Access Compliance Report Public Rights-of-Way (Curb Ramps)

Intersection ID: 31553 Main Street: CALDWELL_RD Cross Street: CALDWELL_RIDGE_PY Location: E

ADA ID: 4909F64B51C5 Ramp Type: Combination1 Initial Pass/Fail: Fail Overall Compliance: No Severity Score: 10

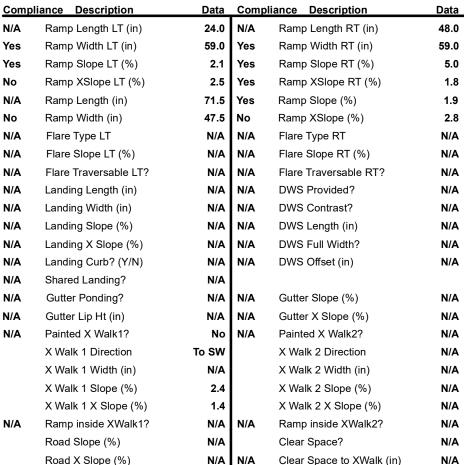
Surveyor Notes:

LT RP < 5%

PROW/ADA:

Not Found, R304.5.1, R304.5.3

Possible Solutions:

Remove & Replace Entire Ramp.
